Second Quarter 2006 Progress Report

Midwest Roadside Safety Facility Mid-States Regional Pooled Fund August 14, 2006

Pooled Fund Consulting Summary

Midwest Roadside Safety Facility April 2006 – August 2006

Figure 2. Bullnose Question

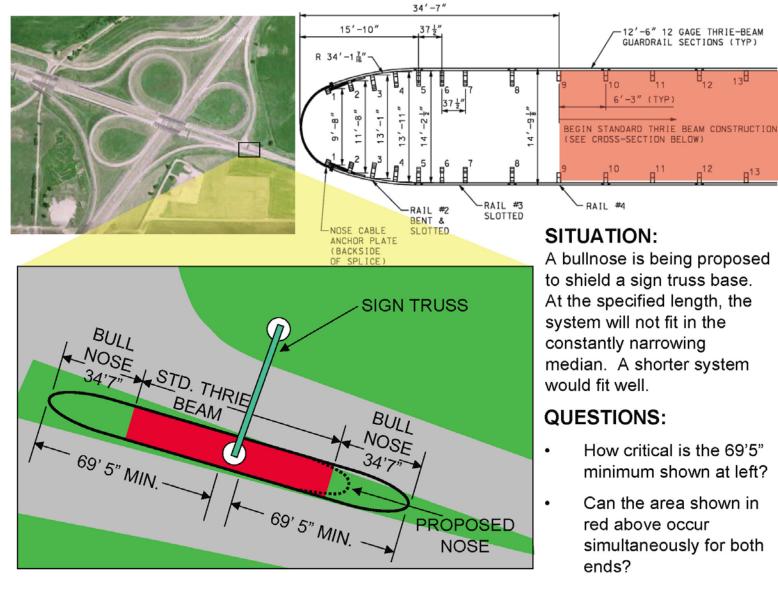
See Figure 2 below.

I have looked at your bullnose barrier question regarding the distance from the nose of the system to the hazard. Based on a somewhat less conservative approach than our original guidelines, we believe you can reduce the 69.5' minimum distance shown in your drawing to 50'. We do not recommend that you shorten the distance any more than that as it may allow larger vehicles impacting the end of the system to impact your sign supports with significant velocity. The new 50' distance should shorten your installation 19.5' on the narrow side of your median.

As for your second question regarding the red area in your drawings, I am afraid I do not understand. The red area in your drawing is not a critical number. The critical number is the distance from the nose of the system to the rigid hazard. This distance is based on the amount of system deflection we saw in tests of a pickup truck impacting the end of the barrier system under NCHRP Report 350 impact conditions. We do believe that this distance can be safely reduced to 50' if need be as stated above.
